Product Change Notification

PCN-PCC-8469-2023

Business Unit	Product Line Code	Type of Change	Action	Date of Issue
PCC - PCB Connectors	AAE	Product Change Notification	Notify Distributors and Field	1/17/2023

Description for Product Change Notification

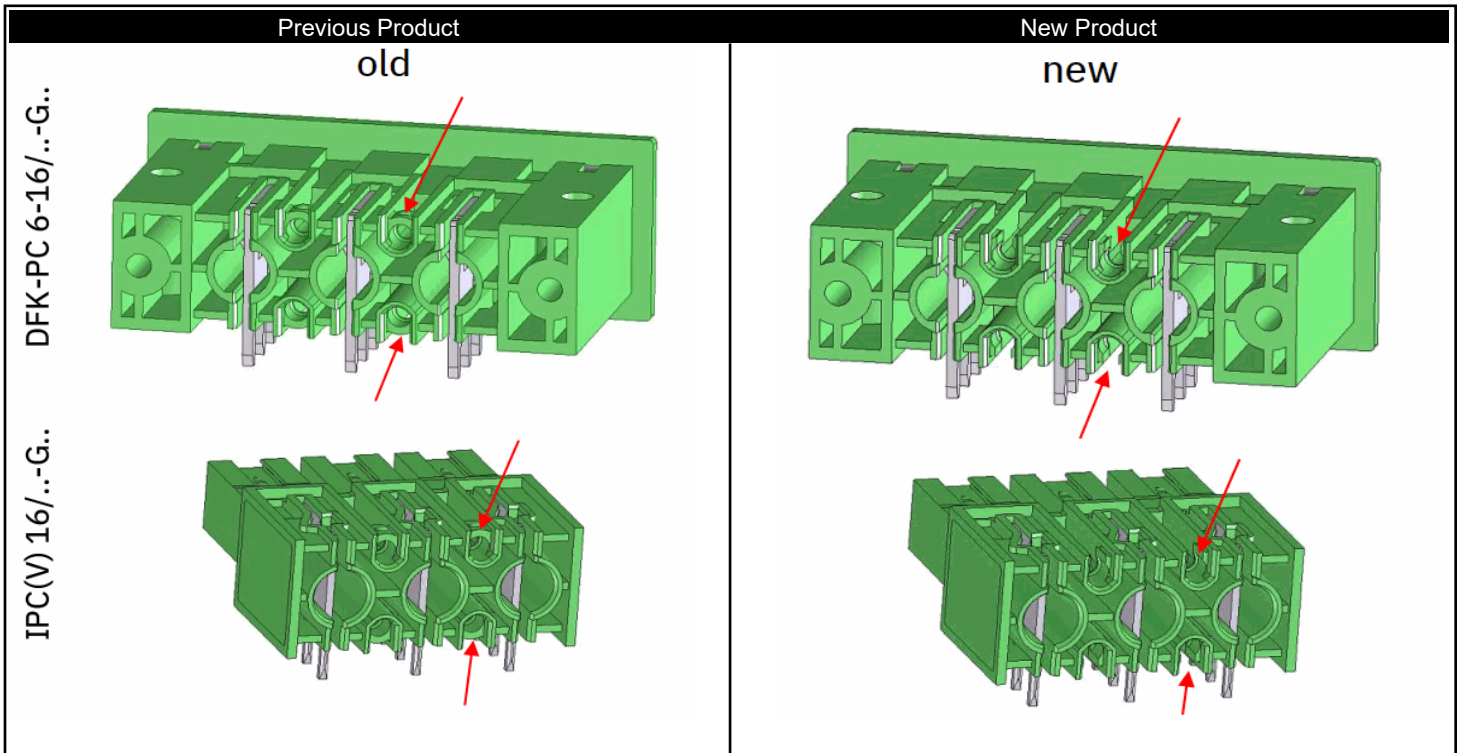
As part of the continuous improvement processes, the connecting ribs will be removed from the housings of IPC(V) 16/..-G.. and DFK-PC 6-16/..-G... This means that these items will have the same contour as the PC(V) 6-16/..-G headers. The external dimensions, pin layout, and technical data will not change. An old vs. new comparison drawing and an item are included within this notice.
